Product Change Notification / SYST-28PENM521

ERRATA - PIC32MZ Embedded Connectivity with Floating Point Unit (EF) Family Silicon Errata and Data Sheet Clarification

Description of Change: Added Silicon revision B3. Updated the Silicon revision to B3 throughout the document.

PIC32MZ Embedded Connectivity with Floating Point Unit (EF) Family Silicon Errata and Data Sheet Clarification

FIGURE 1: Posc CRYSTAL CIRCUIT

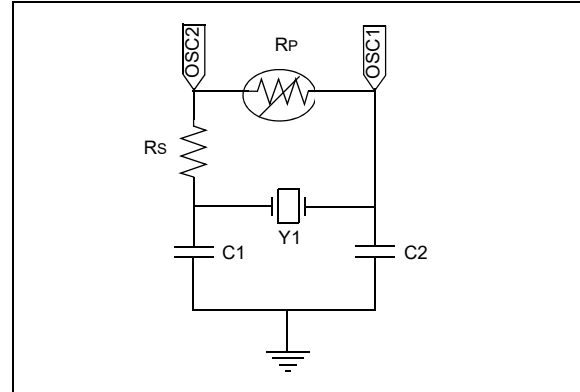
Revision A3 and B3 Silicon: The Posc has been tested in a normal power-up sequence and supports specific crystal operation.

The Primary Oscillator (Posc) has been characterized to operate at 8 MHz, 12 MHz, and 24 MHz when the circuit in [Figure 1](#) is implemented, and the operating conditions listed in [Table 3](#) are met.

- Note 1:** Using any other crystal frequency will require special component selection and characterization.
2: A parallel resistor (Rp) should not be used to increase the gain of the POSC.

64-PIN QFN⁽⁴⁾ AND TQFP (TOP VIEW)

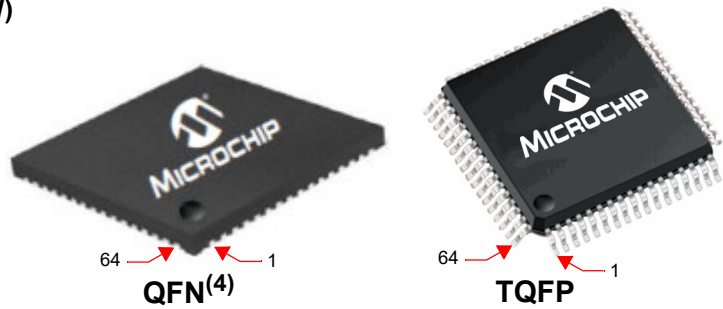
In Table 2. “Pin Names for 64-pin QFN and TQFP Devices” of the current data sheet, the AECRS_{DV} signal was erroneously omitted from the pin number 44 and added to the pin number 62. The correct assignment is shown in bold type in the following table.
